WILLIS AND CROSS ROAD SUBDIVISION,
RESUBDIVISION OF LOTS 4 & 5

Engineering Comments: FINAL PLAT COMMENTS (should be addressed prior to submitting the FINAL PLAT for review and/or signature by the City Engineer):

APPLICATION NUMBER 7 DATE December 15, 2016
 APPLICANT Willis and Cross Road Subdivision, Resubdivision of Lots 4 & 5
 REQUEST Subdivision

DETAIL SITE PLAN

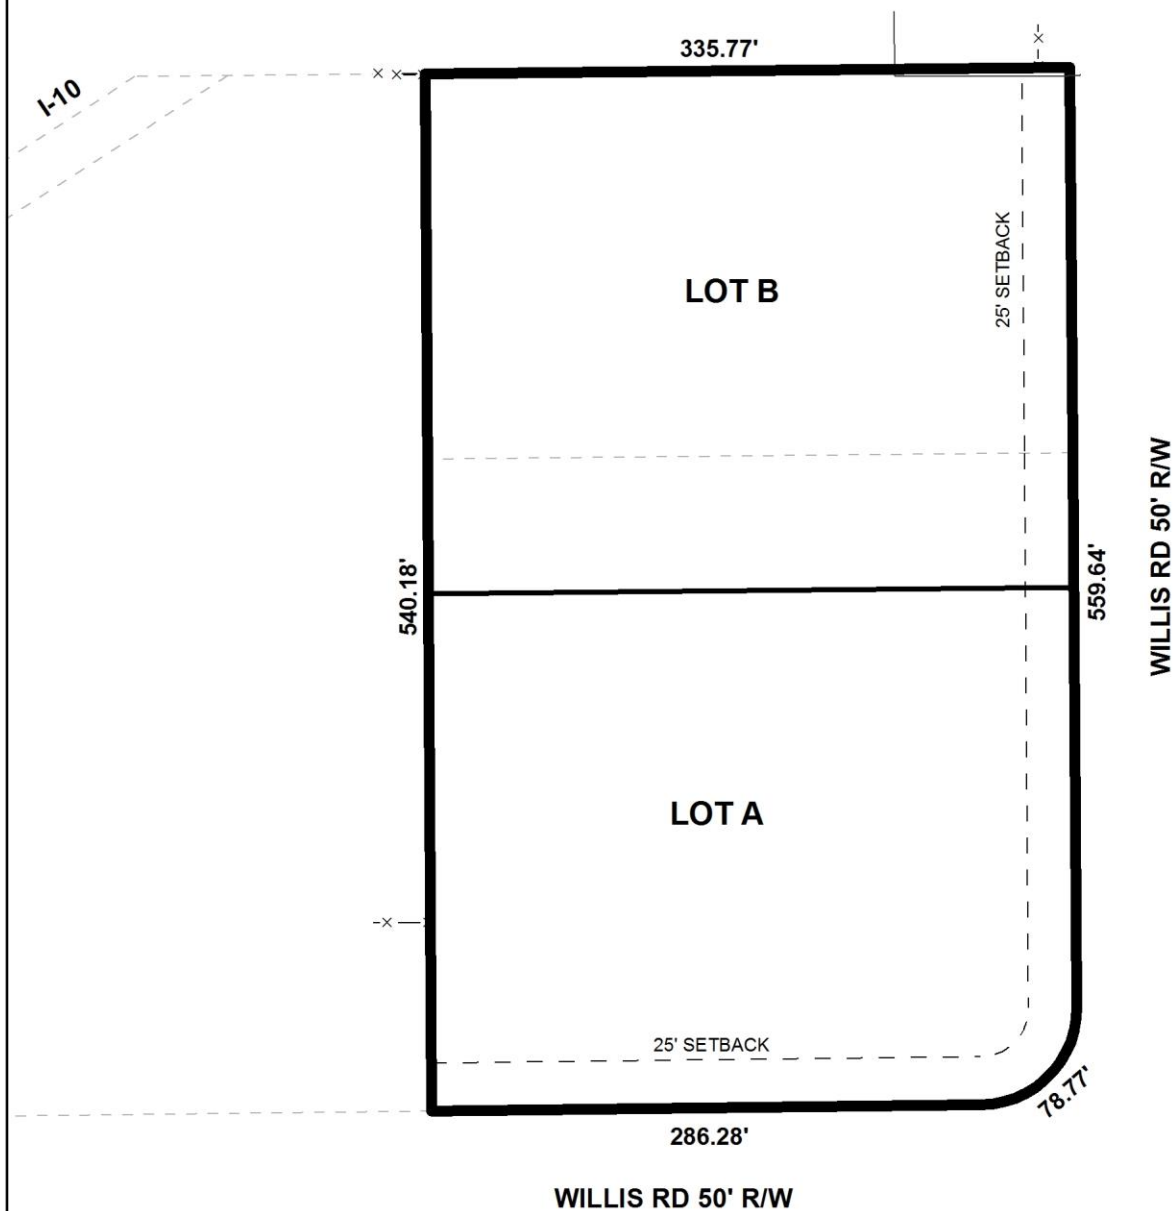
The subject lots front Willis Road, a paved minor street without curb and gutter. As a paved minor street without curb and gutter, this street requires a 60' wide right-of-way width. The right-of-way width is depicted as 50' on the preliminary plat and should be retained on the Final Plat, if approved, as the 2013 subdivision approval did not require dedication of right-of-way. Also, the street that is labelled as "Cross Road" should be revised to read as "Willis Road" on the Final Plat, if approved.

As previously stated, the applicant desires to relocate the interior lot line between the proposed Lots A and B 70'± South of its current location. The relocation of this interior lot line will increase the square footage of the proposed Lot B while reducing the square footage of the proposed Lot A. Despite this, both lots will exceed the 7,200 square foot minimum lot size requirements for lots served by public water and sanitary sewer systems. The lot size information is indicated in both square feet and in acres and should be retained on the Final Plat, if approved.

The 25-foot minimum building setback line is depicted on the preliminary plat along Willis Road, and, if approved, should be retained on the Final Plat.

As a means of access management, a note should be placed on the Final Plat stating that Lots A and B are limited to one curb cut each to Willis Road, with the size, location and design to be approved by Traffic Engineering and conform to AASHTO standards.

- 1) Retention of the right-of-way width along Willis Road;
- 2) Revision of the street label to read as “Willis Road” and not as “Cross Road”;
- 3) Retention of the 25-foot minimum building setback lines along Willis Road;

- 4) Retention of the lot size information in both square feet and in acres;
- 5) Placement of a note on the Final Plat stating that Lots A and B are limited to one curb cut each to Willis Road, with the size, location and design to be approved by Traffic Engineering and conform to AASHTO standards;
